## DRAWINGS AMENDMENT ANNOTATIONS

## REMARKS

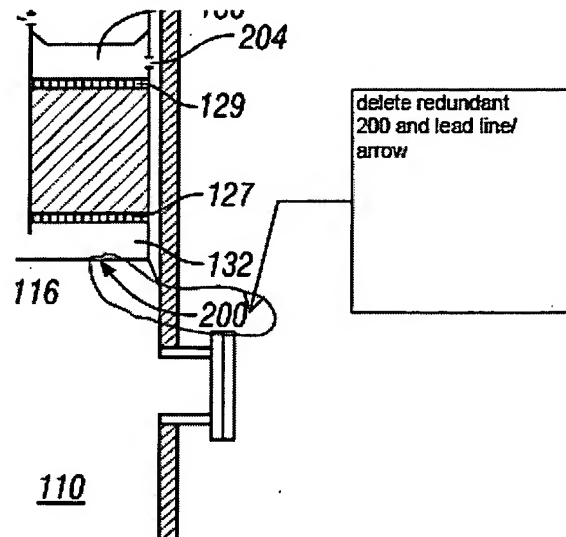
Replacement Sheet 2 is attached hereto in which Fig. 2 is amended to delete one of the redundant 200 reference numerals as shown in the following cropped markup:

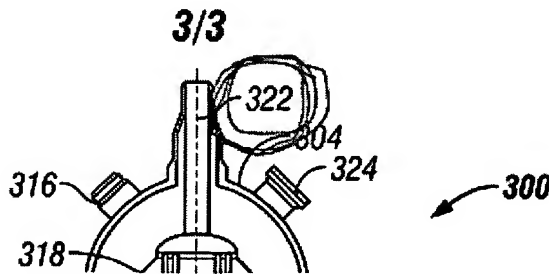
Fig. 2 is amended to remove one of the redundant reference numeral 200's. The office action also objected to the drawings in that reference numeral 322 mentioned at paragraph 28 was said not to be found in the drawings. However, it appears the presence of the reference numeral in the upper central portion of Fig. 3 may have been overlooked as indicated in the following cropped portion of Fig. 3:

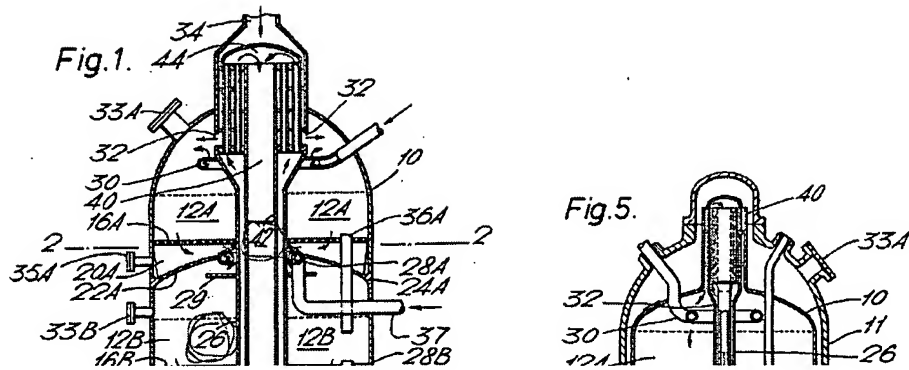
Moreover, the recitation in claim 6 of "a discharge passage in fluid communication between the upper and lower discharge plenums and a shell-side fluid inlet to the heat exchanger" is not met in *Notman* by alleged shell-side feed gas inlets 34, 30, 28A. In claim 6, the discharge plenums are connected by a passage to the shell side of the heat exchanger; in *Notman*, the discharge plenums feed into pipe 26, up to the tube-side of the exchanger 40 where they are cooled and thence to the final catalyst stage via central pipe 42. The tube-side *Notman* configuration of the pipes 26, 42 in a pertinent cropped portion of Fig. 5 is more easily seen by reference to the similar arrangement in the corresponding cropped portion of Fig. 1:
